**Environmental
Protection Agency**

May 24, 2010

RE: PULL-A-PART
3GR01228*DG
STORMWATER
STARK COUNTY

Figure 1: Storage area for crushed cars next to the crusher

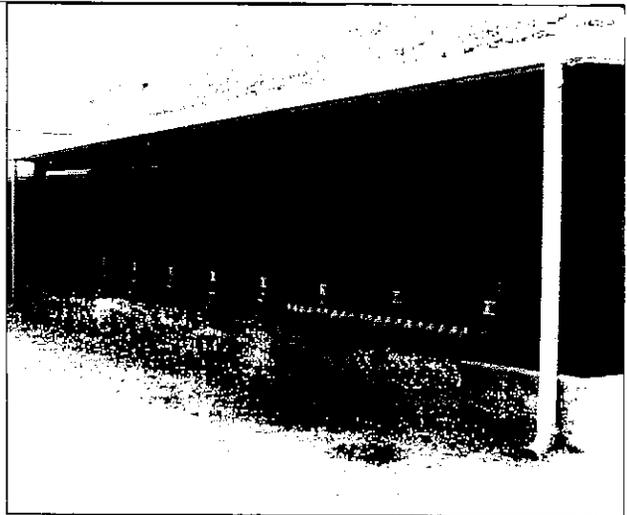
1. While walking around the main processing area we noticed a few areas of concern. The first area of concern is the concrete pad on which the car crusher sits. The area has no berm or secondary containment to control any residual fluids from the crushed cars. You stated that the area is constantly policed to keep it clean. While not required, it is suggested that this area be roofed and a trench drain installed around the perimeter (under roof) to collect any stray liquids.
